STAFF REPORT

SUBJECT: H-2024-0060
Lennon Pointe – PP, PS

LOCATION: 1515 W. Ustick Road, at the southeast corner of N. Linder Rd. and W. Ustick Rd., in the NW 1/4 of Section 1, T.3N., R.1W. (Parcel #S1201223115)

A. Preliminary Plat (dated: 10/25/24)

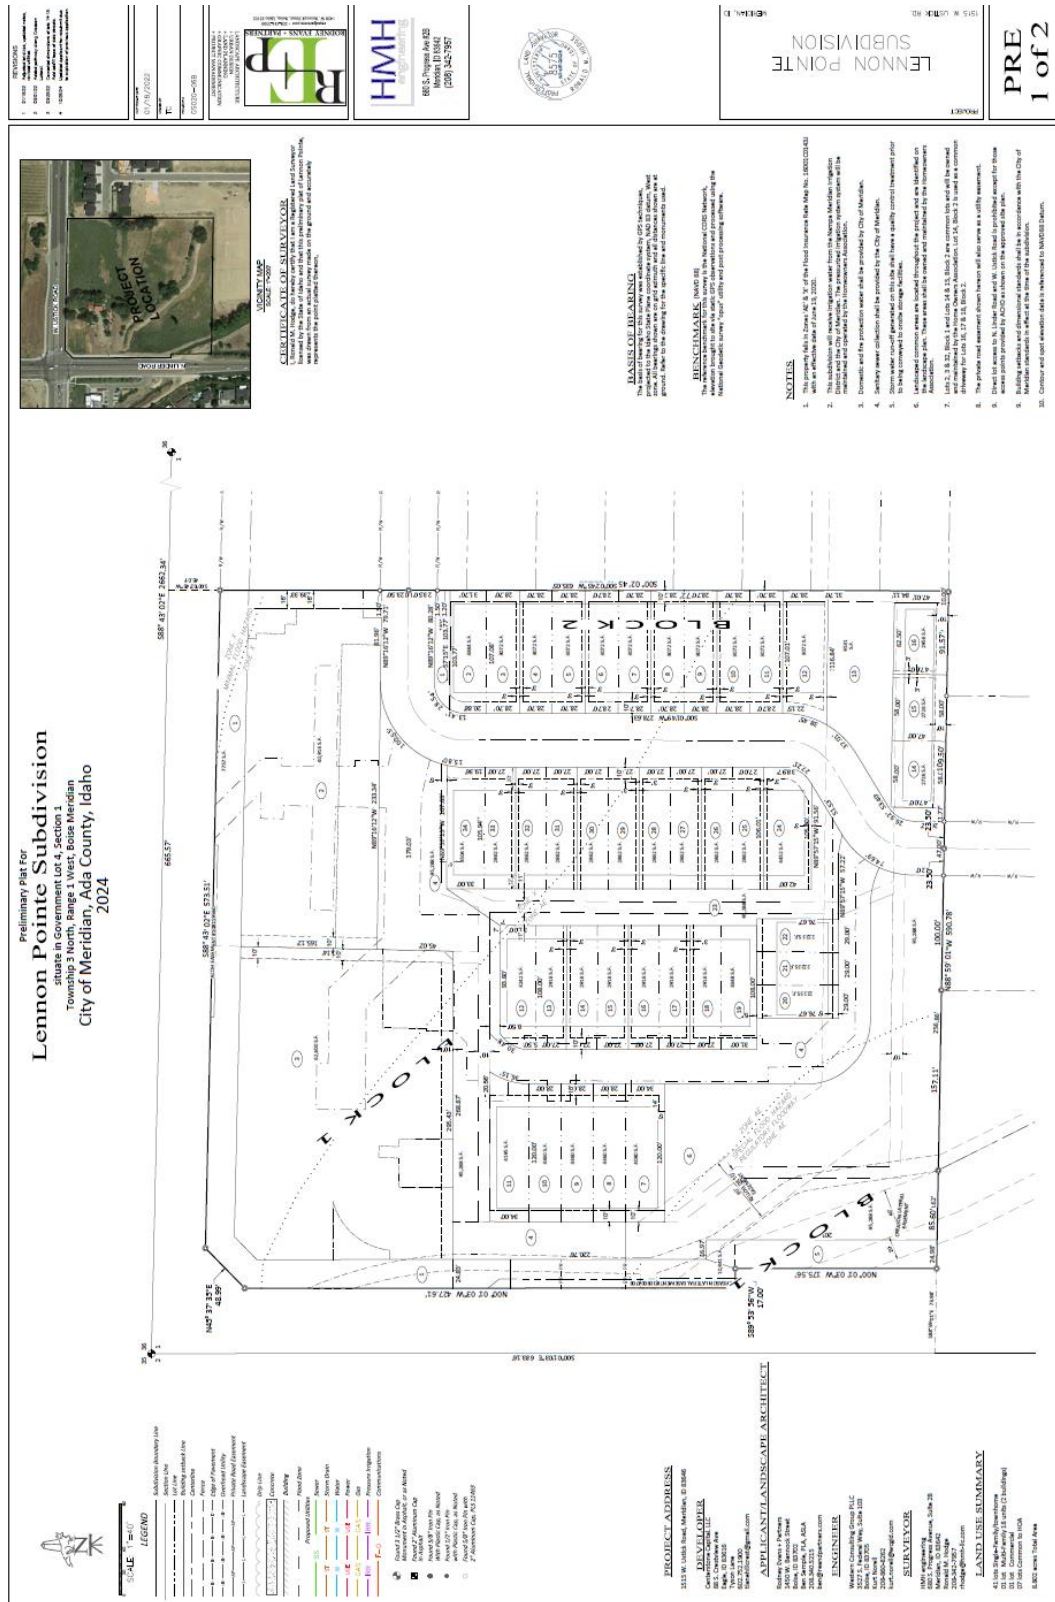
2. The final plat shall include the following revisions:
 - a. Widen Lots 14-16, Block 2 to accommodate the minimum front setback of 20-feet to the face of garage on these lots.

- b. Depict a minimum 20-foot wide perpetual ingress/egress easement on Lot 13 for the common driveway and include a note for the easement requiring maintenance of a paved surface capable of supporting fire vehicles and equipment in accord with UDC 11-6C-3D.8. Alternatively, a separate 20-foot wide common lot could be included for the common driveway.

- c. Plat note #7 includes incorrect common lot numbers; revise accordingly and remove the portion pertaining to the common driveway.
 - d. Depict a 26-foot wide easement for the private street on Lot 4, Block 1 and include a note granting an ingress/egress/cross-access easement to all lots in the subdivision to use the private streets on Lot 4, Block 1.

- g. The private street shall be a loop off the local street (i.e. N. Zion Park Ave./W. Pebblestone Dr.) and shall not extend to the west of N.W. 15th Ln. along the north side of Lot 11, Block 1; the private street shall terminate on the west side of N.W. 15th Ln.

- h. Depict an access easement for the driveway proposed via N. Linder Rd. to the commercial property on Lot 3, Block 1 and for the driveway along the north side of Lot 11, Block 1 between the townhomes and commercial lot; the easements should grant access to all lots within the subdivision.

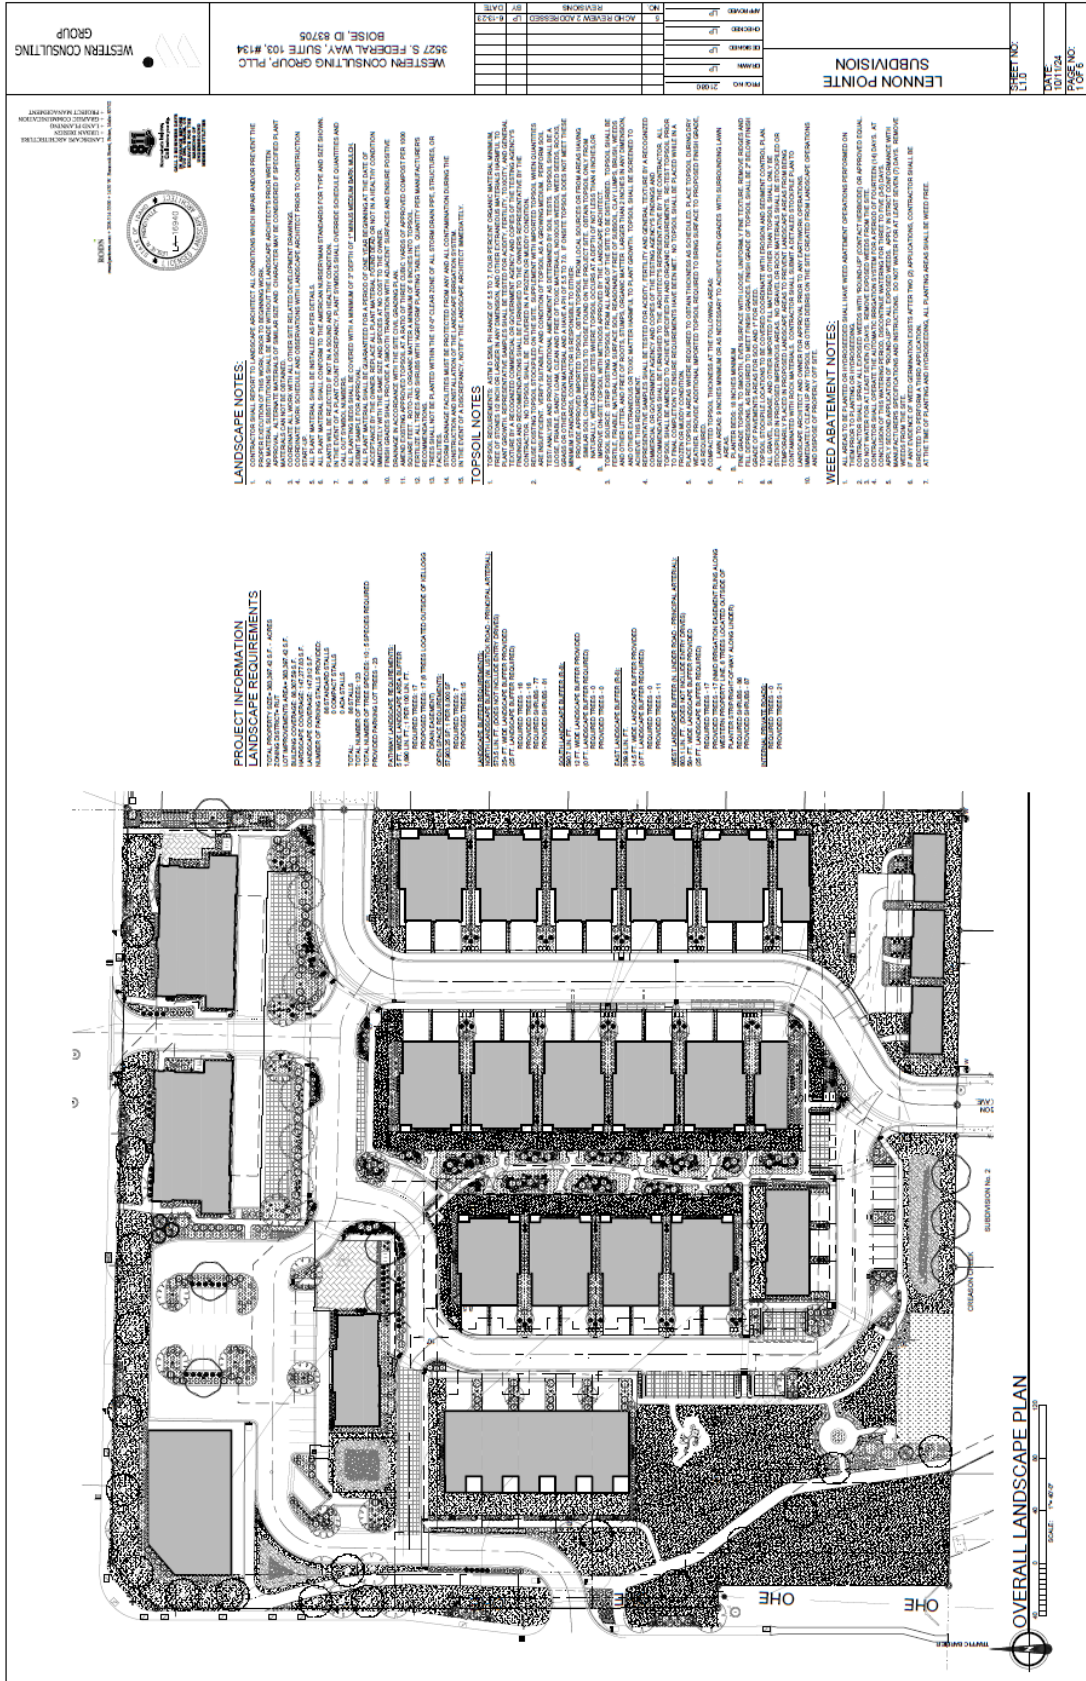
- a. All pedestrian crossings that cross the private street and any drive aisle shall be depicted with brick pavers, stamped concrete, or equal, as outlined in UDC 11-3A-19B.4.b and per requirement of the development agreement.

- c. Clearly depict and label the irrigation district easements for the Kellogg Drain and the Creason Lateral; ensure no trees are placed in these easements. If easements prevent compliance with UDC landscape standards, alternative compliance may be requested to the standard.

- d. Demonstrate how the arterial street buffers comply with the enhanced buffer requirements listed in UDC 11-3G-3B.3 and 11-3B-7C.3f; make revisions as necessary to comply with these standards.

- f. Depict landscaping within the street buffers along Linder and Ustick Roads per the standards listed in UDC 11-3B-7C.3e, which require lawn and other grasses requiring regular mowing to comprise no more than 65% of the vegetated coverage of the buffer; all other vegetated coverage shall be mulched and treated as planting area for shrubs or other vegetative cover.

- g. Revise the calculations table to reflect a minimum of one (1) deciduous shade tree in common open space areas for every 5,000 (instead of 8,000) square feet of area in accord with UDC 11-3G-5B.3 to comply with the current standard.

- h. Depict a dense 25-foot wide landscape buffer to residential uses entirely on the C-C zoned property; *or*, split between the C-C and R-15 zoned properties, with dense landscaping consisting of a mix of evergreen and deciduous trees, shrubs, lawn, or other vegetative groundcover that allows trees to touch within five (5) years of planting as set forth in UDC 11-3B-9C.
